# MEMORANDUM

<b>Date:</b> July 7, 2020	
<b>To:</b> Gian Martire, Senior Planner	<b>Organization:</b> City of Cupertino
<b>From:</b> RRM Design Group	<b>Title:</b> Architectural Review Team
<b>Project Name:</b> Cupertino Consulting Architectural Review Services	<b>Project Number:</b> 1832-00-UR19 (20-01)
<b>Topic:</b> Westport Cupertino Density Bonus Waiver Review – Enhanced Senior and Family Living Project

*Proposed Project - Site Plan*

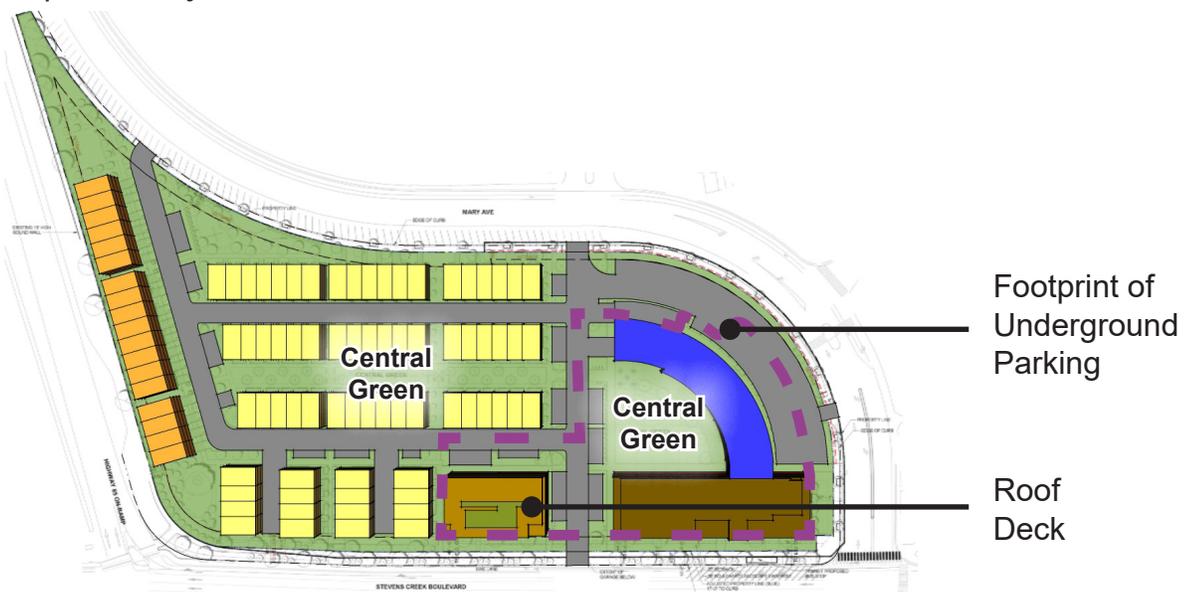
In order to provide a baseline understanding of the currently proposed project, Site Setbacks Sheet G203 was brought into Sketchup, a 3D modeling program, at scale (1 inch = 40 feet) as indicated on the plan sheet. This to-scale site plan provided the foundation for recreating the proposed project in 3D in order to allow for the more in-depth analysis requested by the City as part of this review effort. Other relevant project information, such as property boundary locations, setback locations, floor-to-floor

heights, was also captured in the model to inform the analysis portion of this effort as shown below. It should also be mentioned that the slope line setback standard was also modeled at the 45-degree angle from curblines to allow for a clear understanding of how this standard would or would not affect the project design.

***Project without Height or Slope Setback Line Waivers - Site Plan***

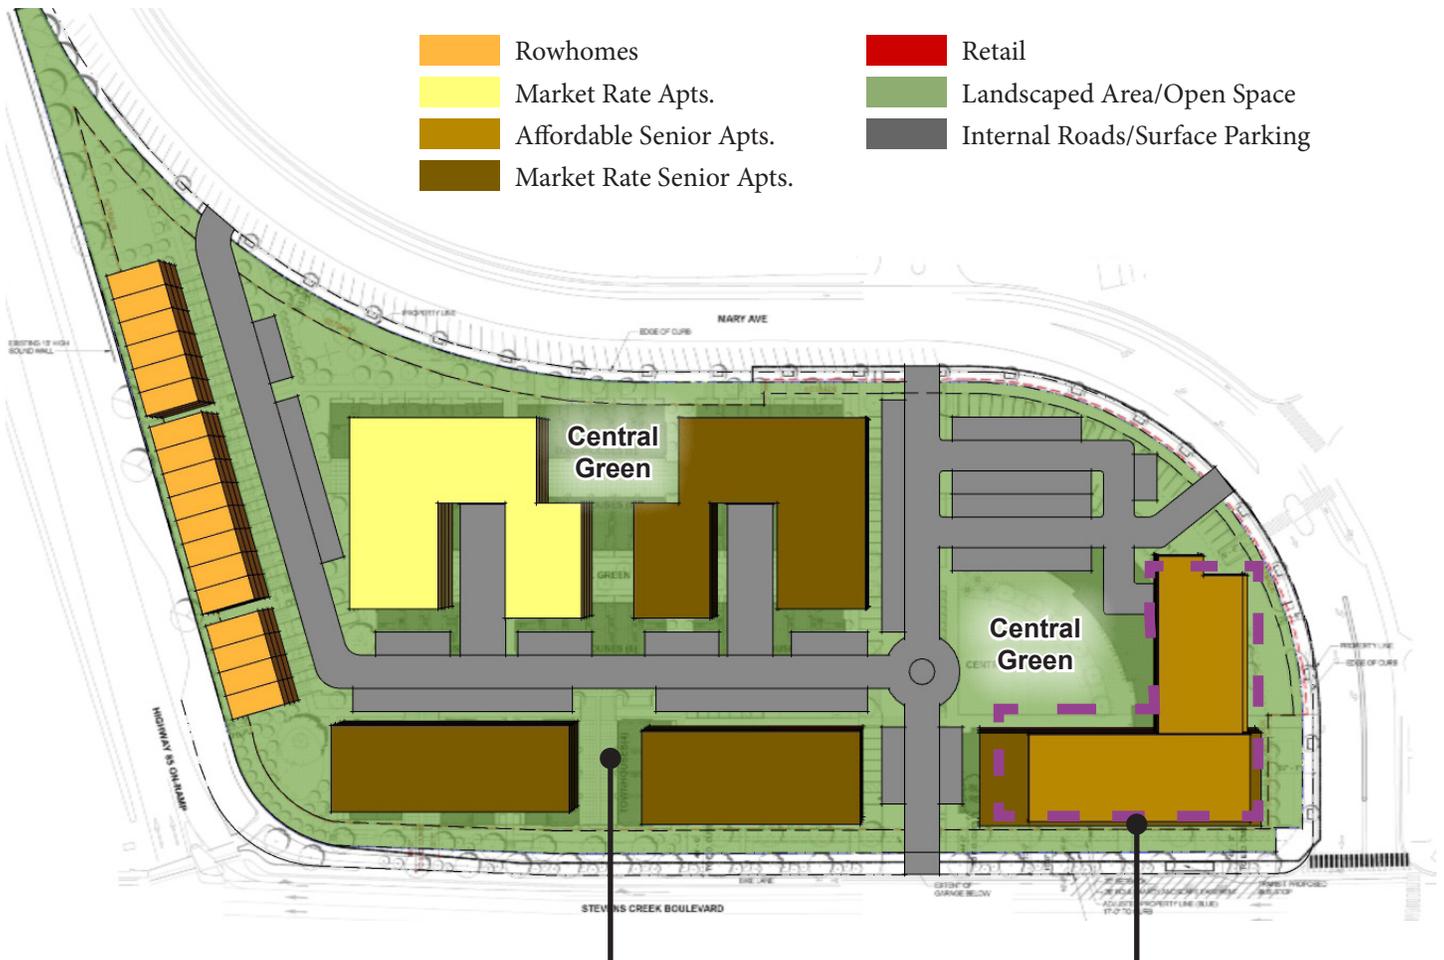
Additional internal roads, surface parking, and building footprints limit ground level open space.

Assumed footprint of underground parking.

Common residential 'Central Green' open space broken up and reduced in size.

Units at 4th story reduced in size to accommodate slope setback.

Retail floor-to-floor height reduced to 15-feet.

- Decrease in total size of Below Market Rate Senior Apartment units at top floor due to slope line setback requirement along Stevens Creek Boulevard and portion of Mary Avenue.
- Loss of required common residential and common landscape open space areas at ground level to accommodate reconfiguration of building footprint area, surface parking, and internal roadway layout, so that the revised design would not meet the open space requirements of the HOCSP.

**Project at Base Density - Site Plan**

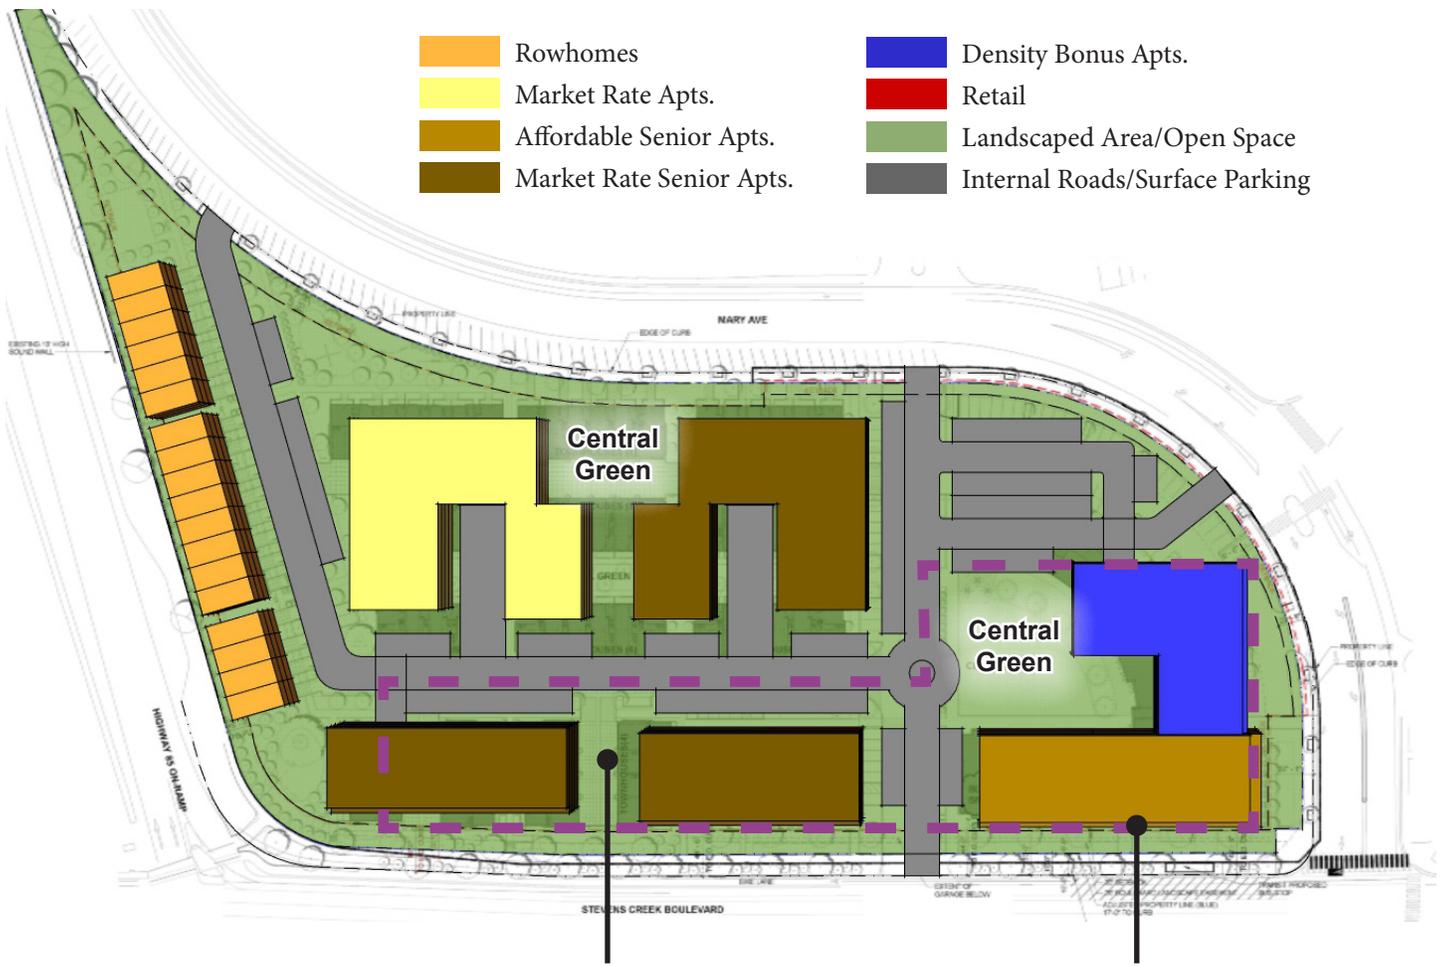
Required Common Open Space maintained, with refined ‘Central Green’ concept.

Assumed footprint of underground parking.

Garage/Tuck-Under parking at internal drive aisle.

Height minimized to three-stories along Steven's Creek Blvd.

Retail floor-to-floor height reduced to 15-feet.

**Project with Density Bonus - Site Plan**

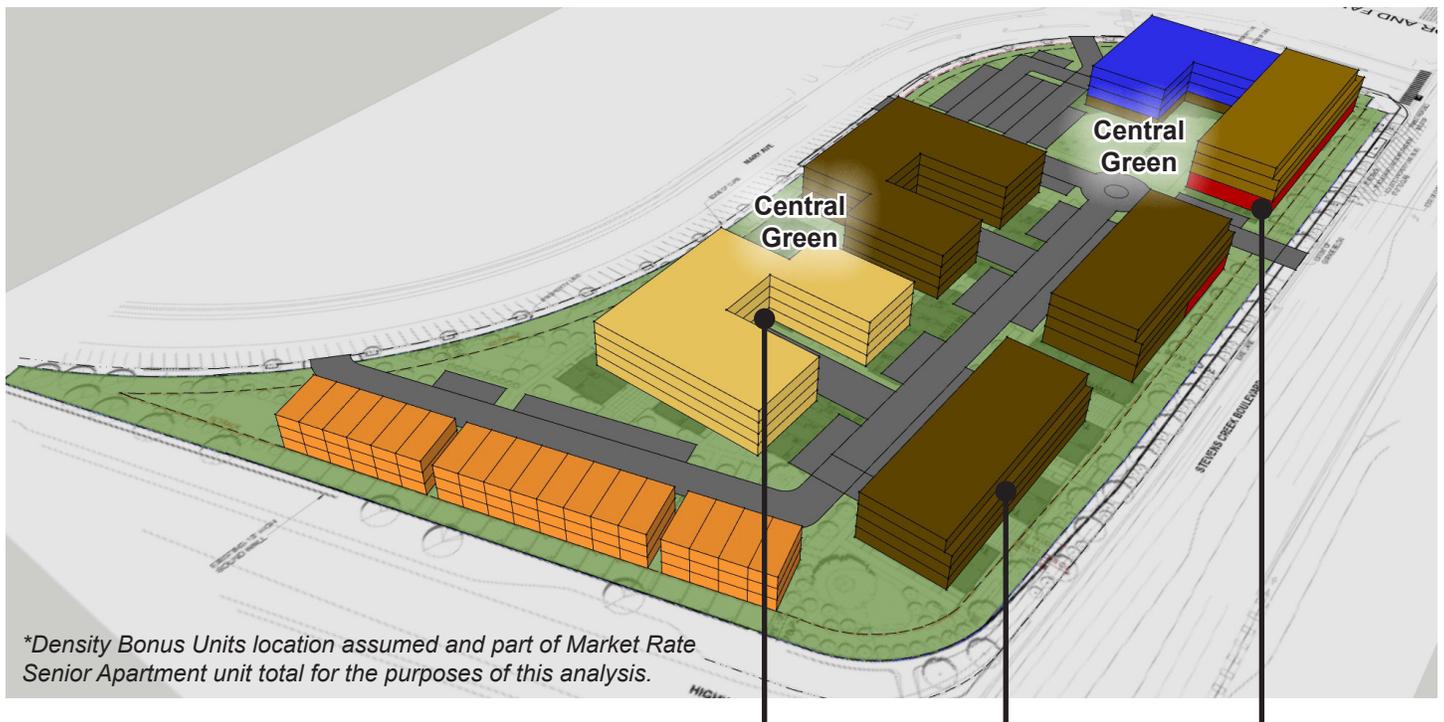
Required Common Open Space maintained, with refined 'Central Green' concept.

Assumed footprint of underground parking. Loss of in-unit garages at Townhomes replaced at underground parking.

Garage/Tuck-Under parking at internal drive aisle.

Units at 4th story reduced in size to accommodate slope setback.

Retail floor-to-floor height reduced to 15-feet.

- Decrease in total size of Below Market Rate Senior Apartment units at top floor due to slope line setback requirement along Stevens Creek Boulevard and portion of Mary Avenue.
